**Economic Commission for Europe****Administrative Committee for the TIR Convention, 1975****Technical Implementation Body****Fifth session**

**eTIR conceptual, functional and technical specifications:****Version 4.4****Concrete amendment proposals****Note by the secretariat****I. Background and mandate**

Figure I  
Current customs management of guarantees class diagram

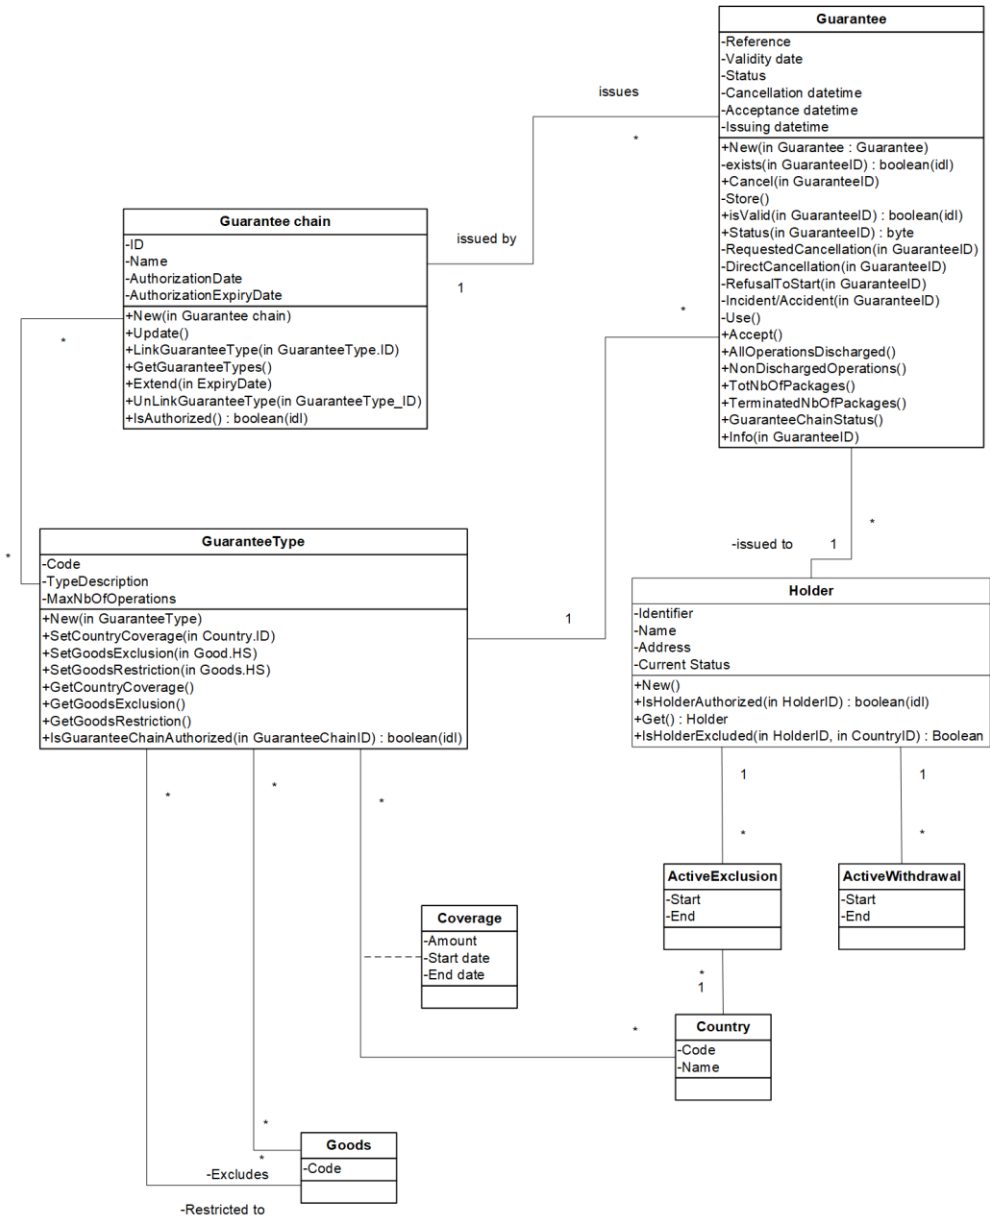
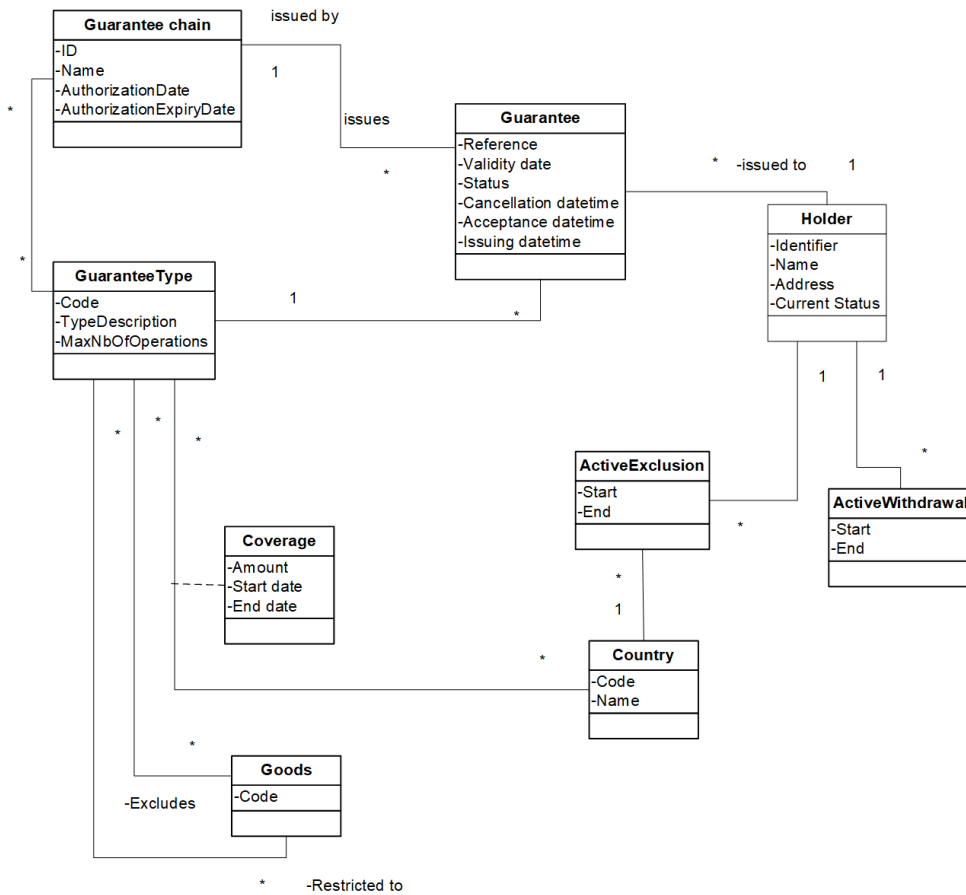
23. UML Class diagrams used in version 4.3 of the eTIR functional specifications contain not only classes, their relationships and their attributes, but also a set of methods that were aimed at facilitating the development of the eTIR international system. As such, these methods have little to no use for the countries that wish to amend their customs system to implement the eTIR procedure. Figures I and II below show the difference between the current and the simplified version of the customs management of guarantees class diagram (Figure 1.19 of the eTIR functional specifications).

24. At its third session, TIB agreed to simplify the class diagrams.

Figure V  
**Business Process Diagram for the Start TIR operation process**

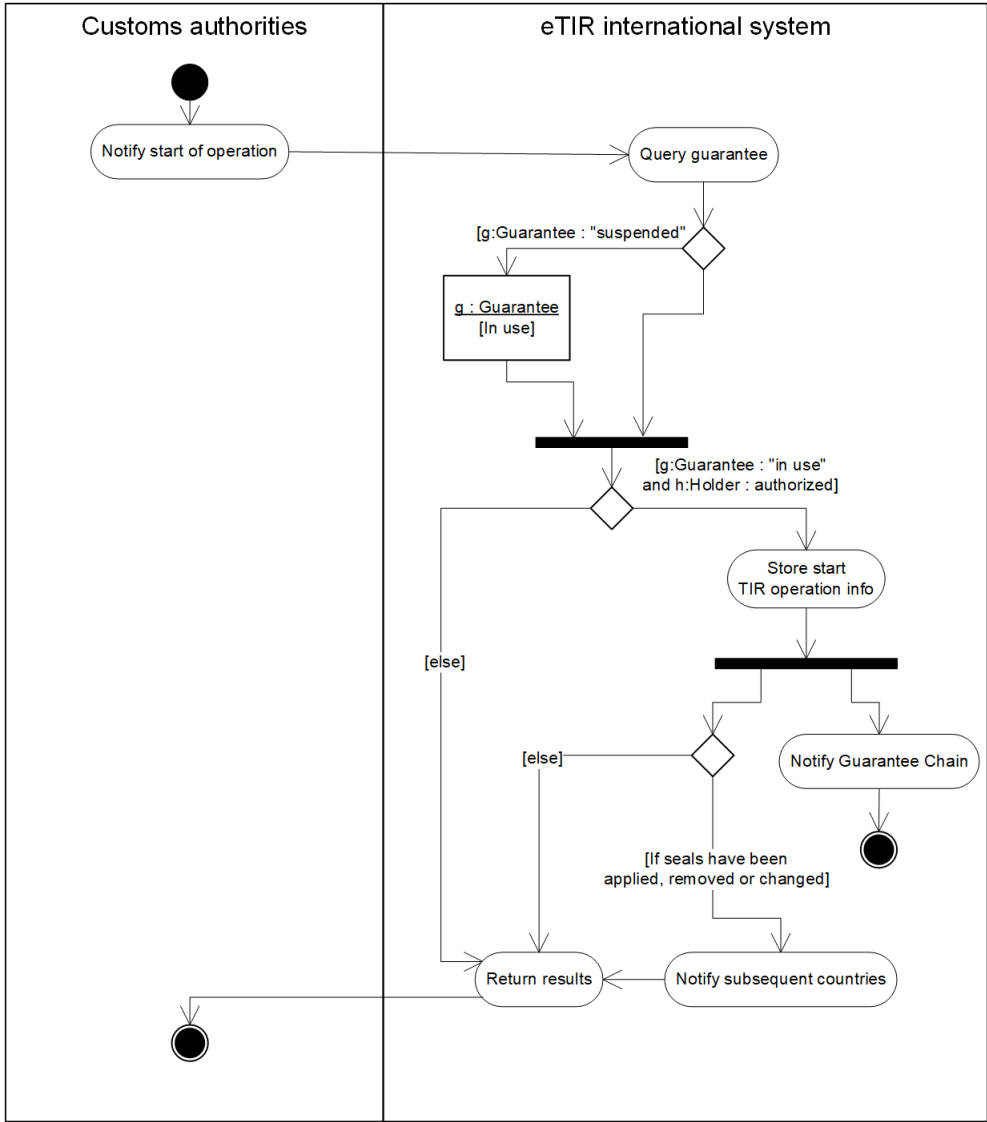
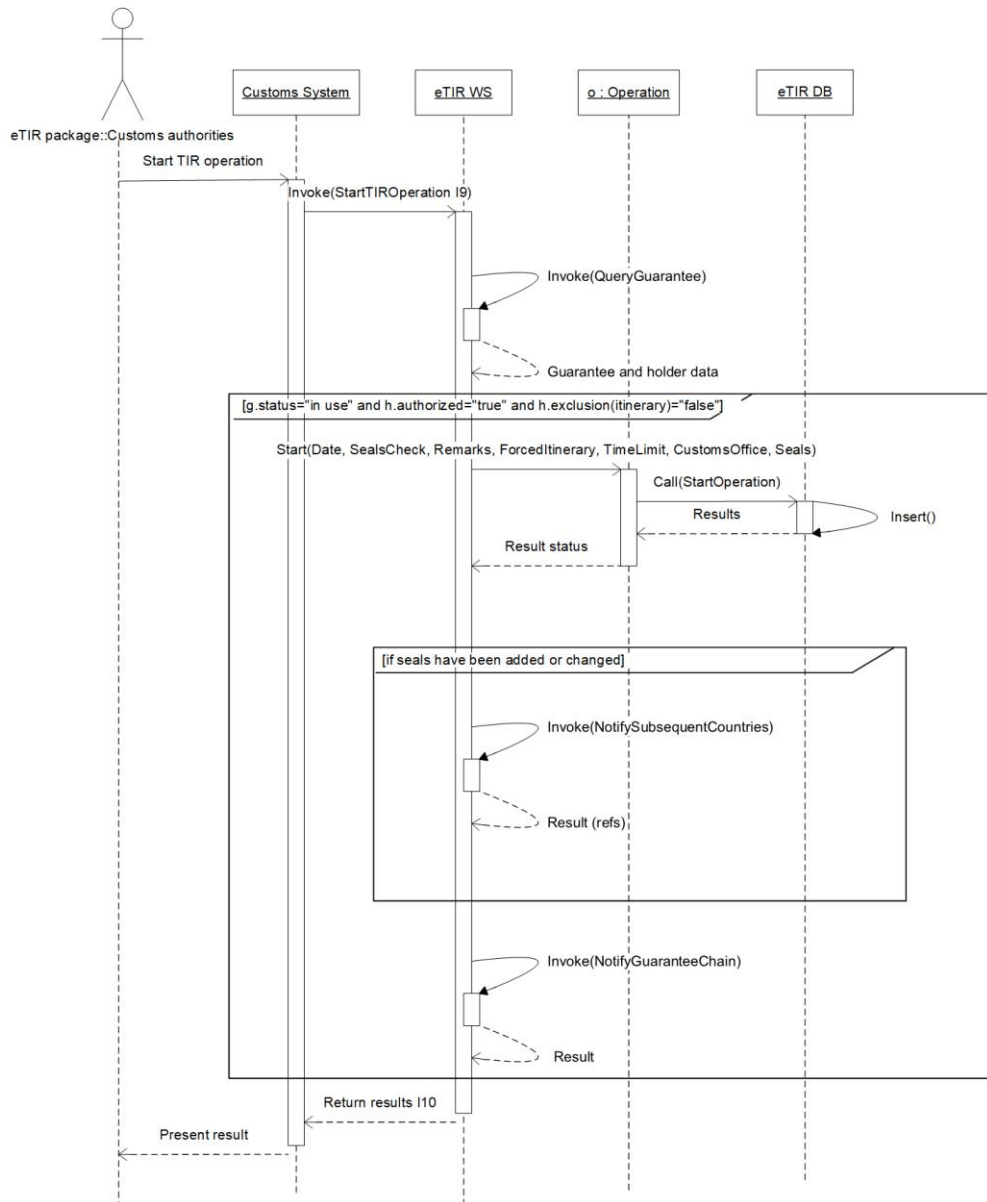
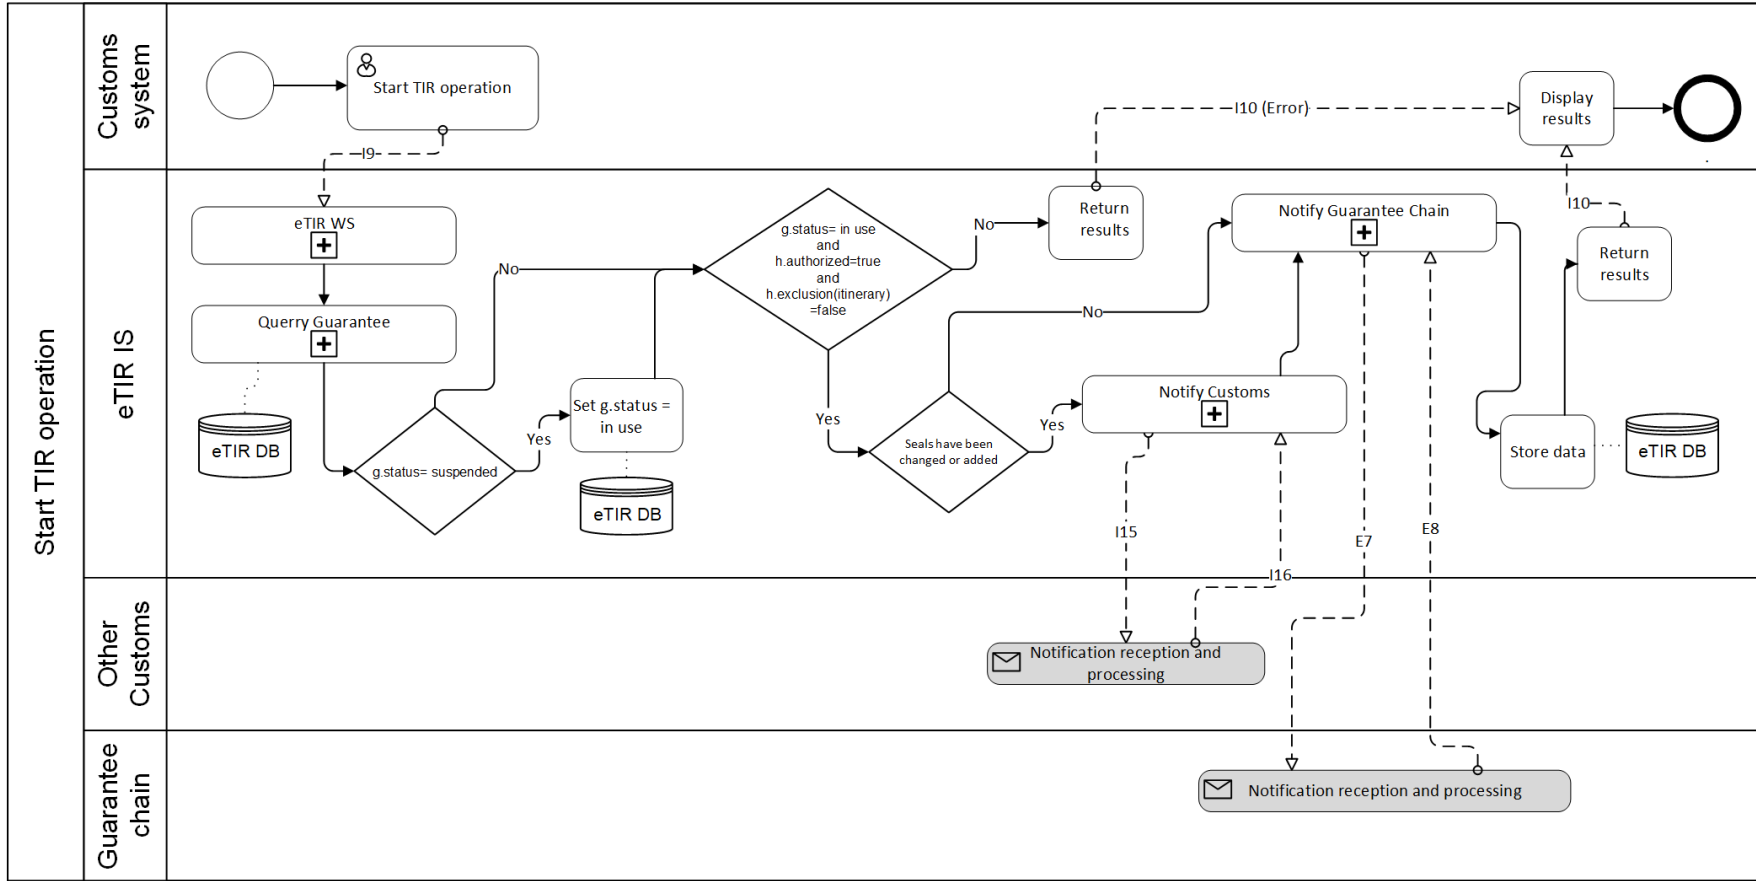
25. In version 4.3 of the eTIR specifications, in line with the Unified Modelling Methodology (UML) chosen originally for the eTIR project, the modelling of processes is done using UML activity and sequence diagrams. In recent years, the business process model and notation (BPMN) has gained in popularity in both the business and Information and Communication Technologies (ICT) communities and is, therefore, better understood by laymen and experts alike. With that in mind, TIB might wish to consider if, in version 4.4 of the eTIR specifications, BPMN should replace the activity and sequence diagrams used in version 4.3. Figures III, IV and V below show the UML activity diagram (Figure 12 of the eTIR concepts), UML sequence diagram (Figure 1.9 of the eTIR functional specifications) and the Business Process Diagram for the Start TIR operation process.

26. At its third session, TIB agreed to replace the existing diagrams (in Unified Modelling Methodology – UML) in the conceptual and functional specifications with the newly proposed diagrams (in Business Process Model and Notation – BPMN), in line with the examples above.
